HP PERMIT NUMBER: HP-0687-2025

PROPERTY ADDRESS: 1602 S. Lewis Avenue

STAFF REPORT August 07, 2025 HP-0692-2025

**PROPERTY ADDRESS:** 1519 E 21st Street

2025

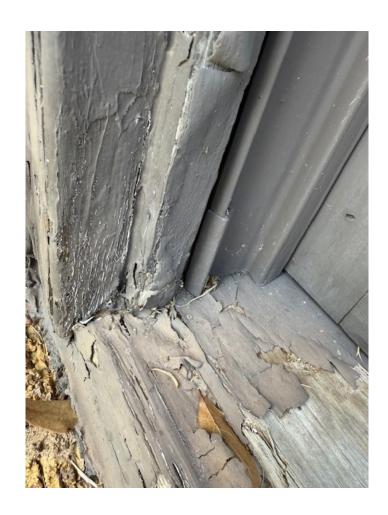
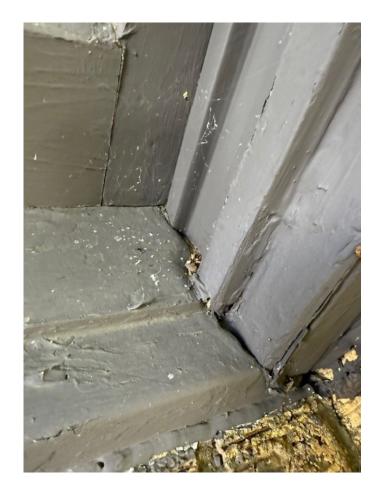
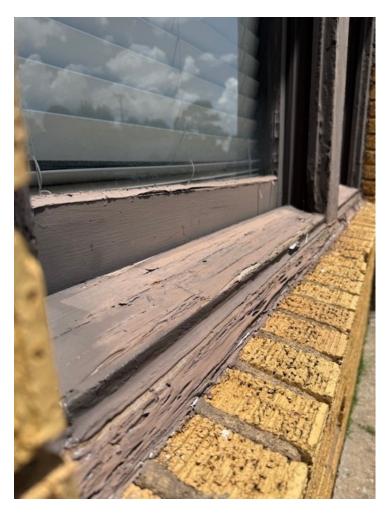
1. The applicant proposes the replacement of all windows due to reported water damage and rot. The proposed replacement windows are Jeld-Wen, double hung, divided light, wood windows. The replacement windows would maintain the same pattern and style as the originals.

At the July 31<sup>st</sup> meeting, the subcommittee voted to recommend approval with the condition the applicant provide the muntin profile.

Another View of West Facade

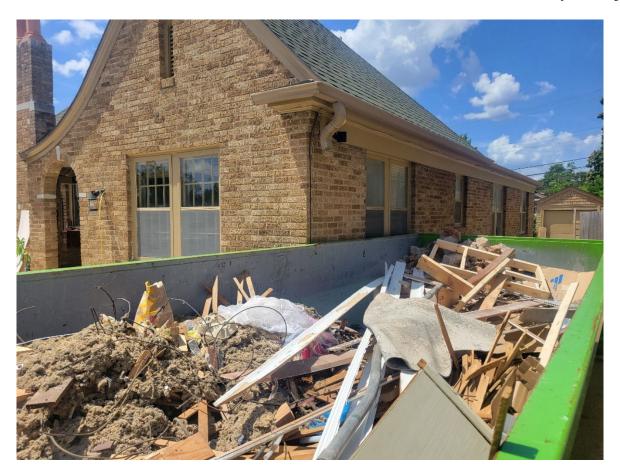
There are 6 hung wood windows and 3 basement window holes existing on the west facade of the home. 3 of the hung windows and 1 basement window have been

determined by staff to have minimal visibility due to the bump out and are not included in this application. Thus, the west side proposed replacements include 3 hung windows and 2 basement windows. The first two windows closest to the face of the house on the west side are currently hung/wood windows. The applicant proposes those window be replaced with a vinyl slider window. The window closest to the rear is hung/wood and the applicant proposes to replace it with a hung vinyl window. The two basement windows holes on the west side are currently boarded up, with no existing windows. The applicant proposes to install vinyl slider windows with an even sash split.
